RESPONSE TO SUBMISSIONS

**ALESCO SENIOR COLLEGE
27 CHAPMAN STREET, CHARLESTOWN
LOTS 18, 19, 20 DP23975**

4 NOVEMBER 2020

STORMWATER PLAN

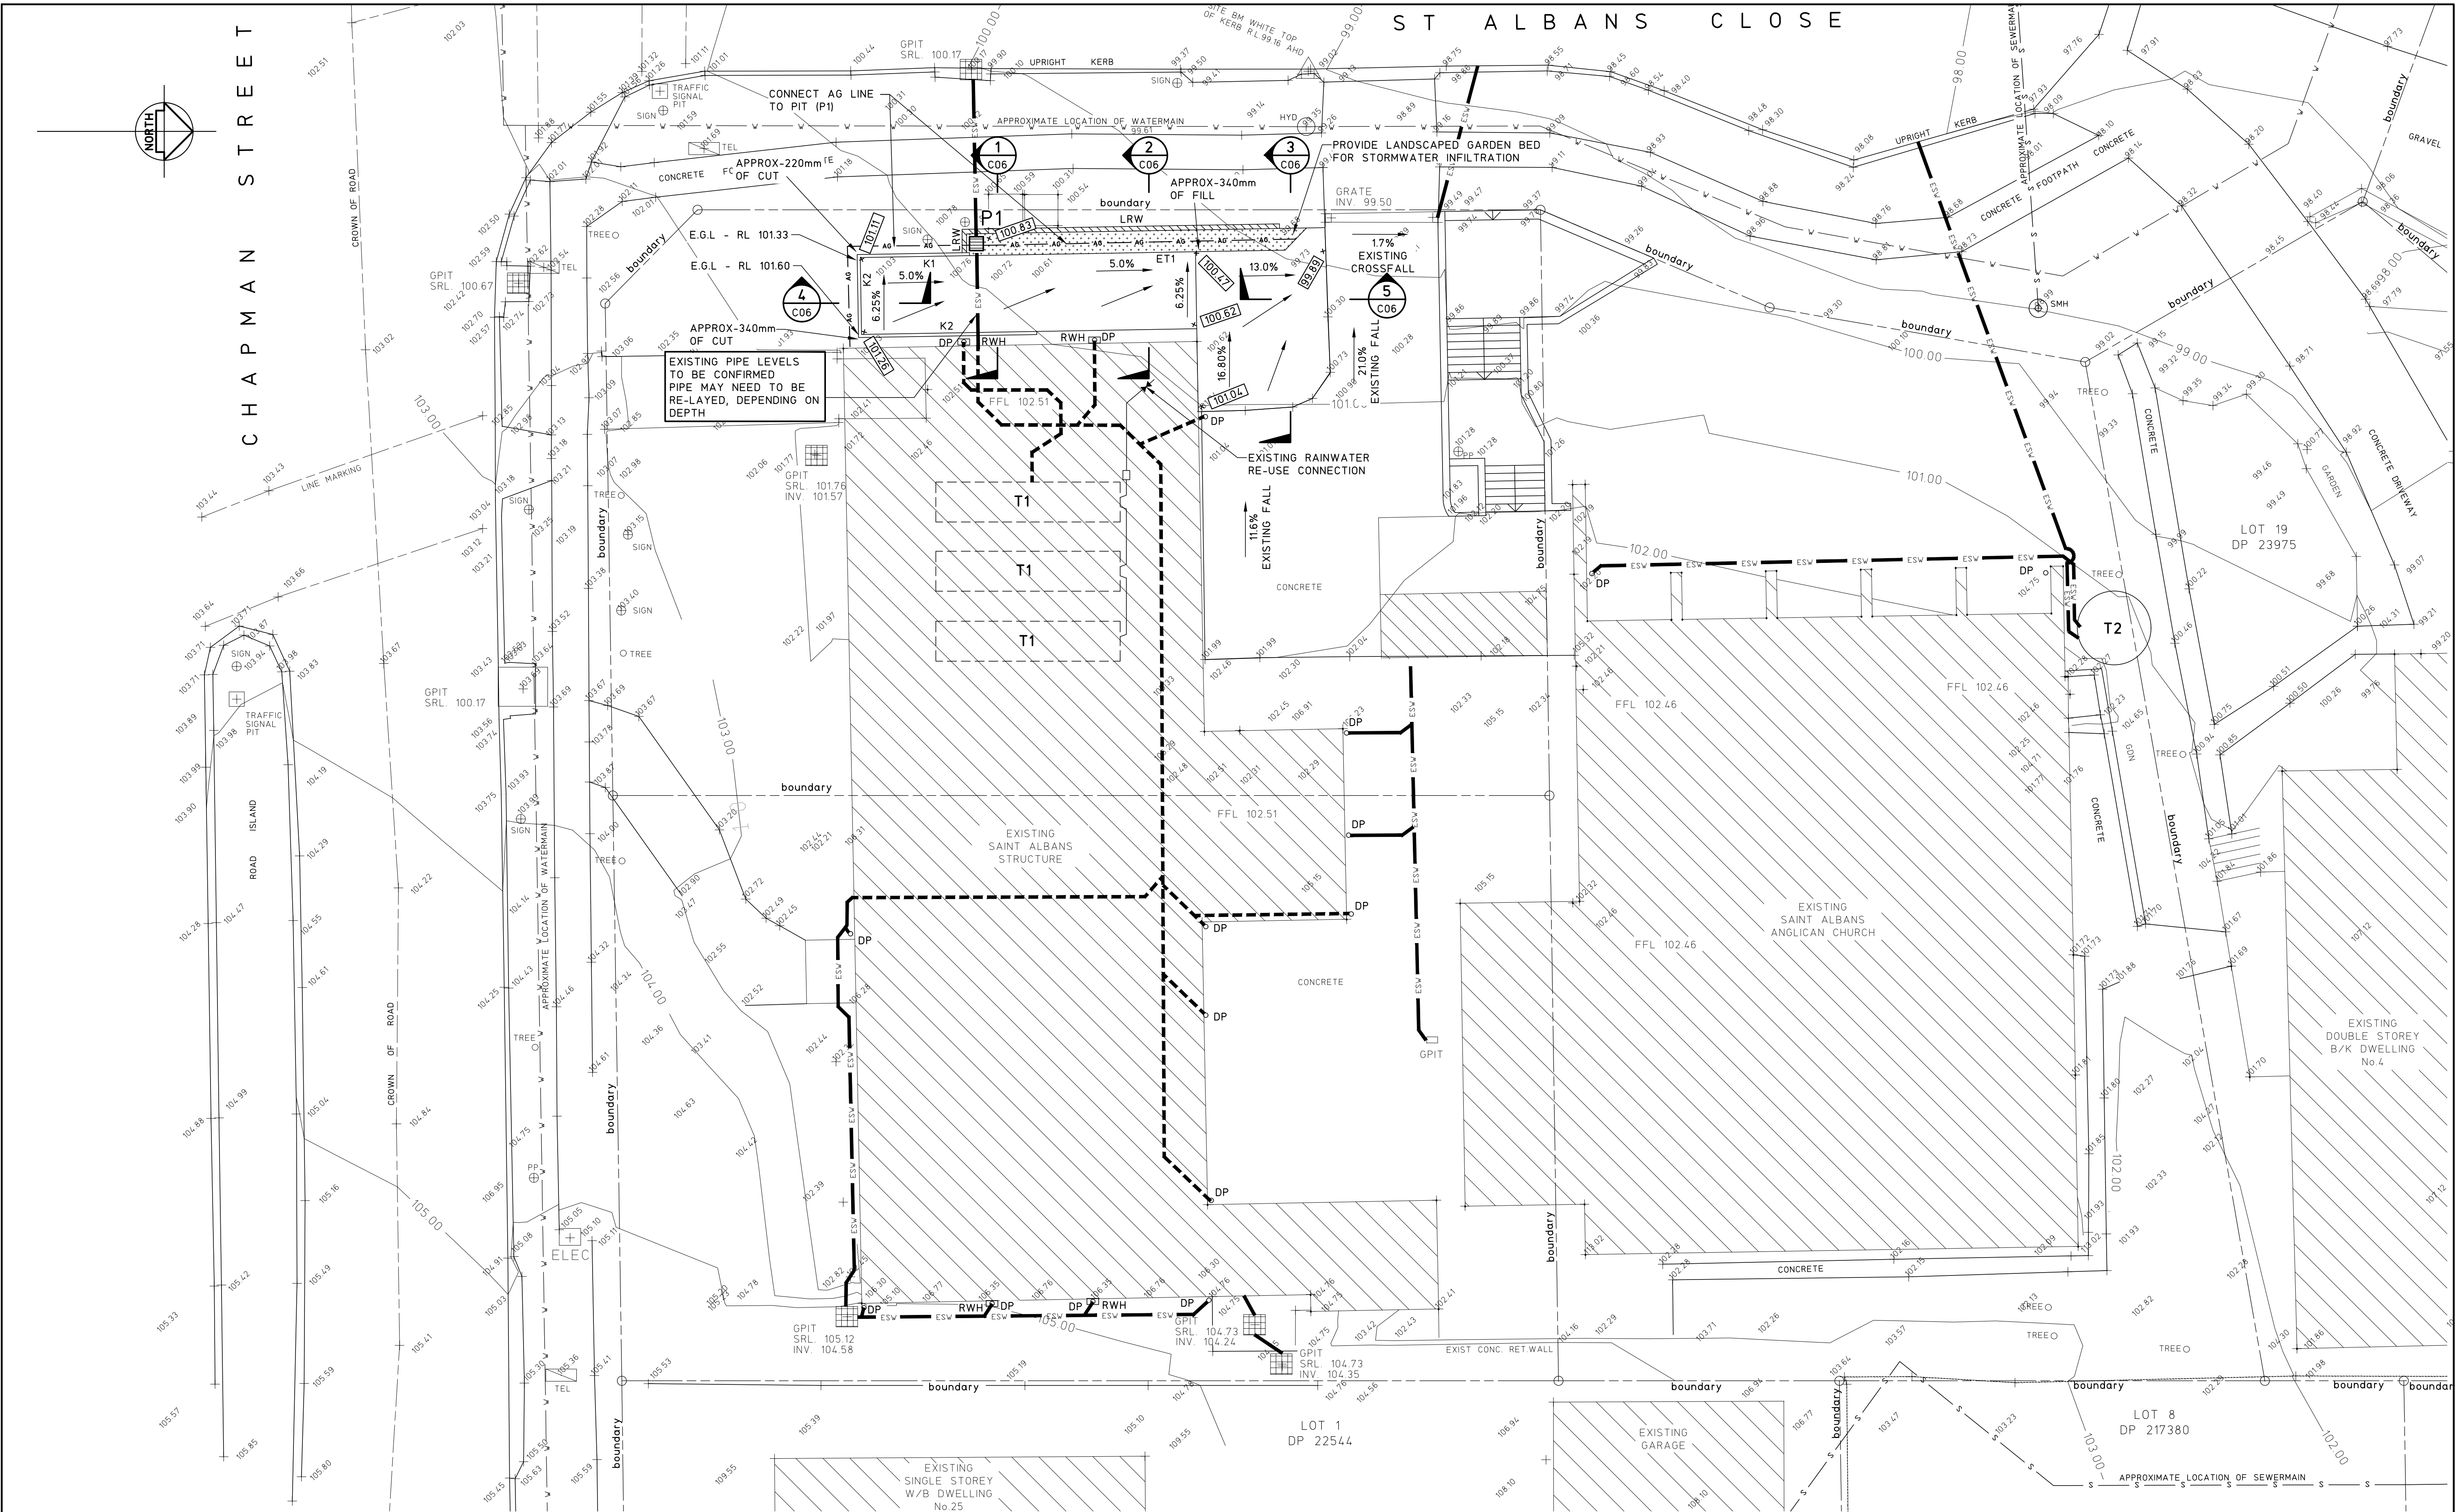
Provide final proposed levels in relation to current levels on the site and adjoining sites, including long sections through the site.	Refer to the attached updated civil plans included in Attachment 1. The only change to levels is the additional carparking area. All other levels remain as per existing.
	Confirm whether the disturbed soils would be re-used on the site (i.e. for landscaping) or whether soils would be required to be disposed of off-site.	There is the potential to re-use a portion of the removed topsoil within the landscaping, with the remainder to be classified and exported in accordance with EPA Guidelines.
